Access Compliance Report

Public Rights-of-Way

| Intersection ID: 13959 | Main Street: CLEVELAND_AV | Cross Street: E_PARK_AV | Location: W |
| ADA ID: 1ACC92968DE3 | Ramp Type: Directional1 | Initial Pass/Fail: Fail | Overall Compliance: No |

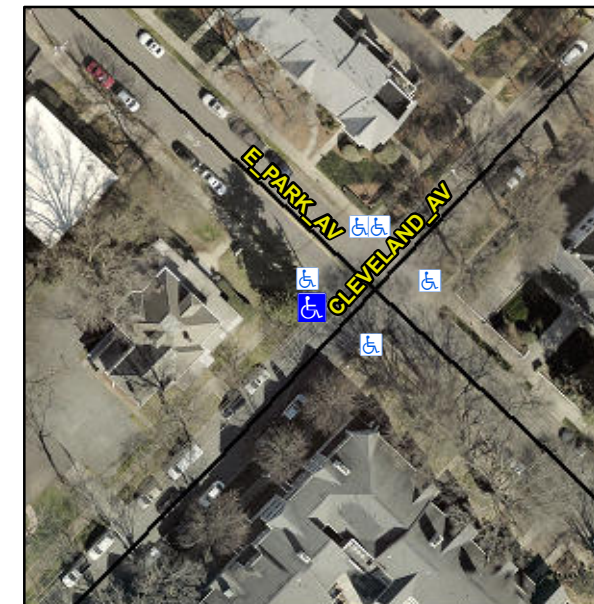
R304.5.3

| Compliance | Description | Data | Compliance | Description | Data |
|------------|-----------------------|-------|------------|-----------------------------|------|
| No | Ramp XSlope (%) | 2.9 | | | |

Remove & Replace Entire Ramp.
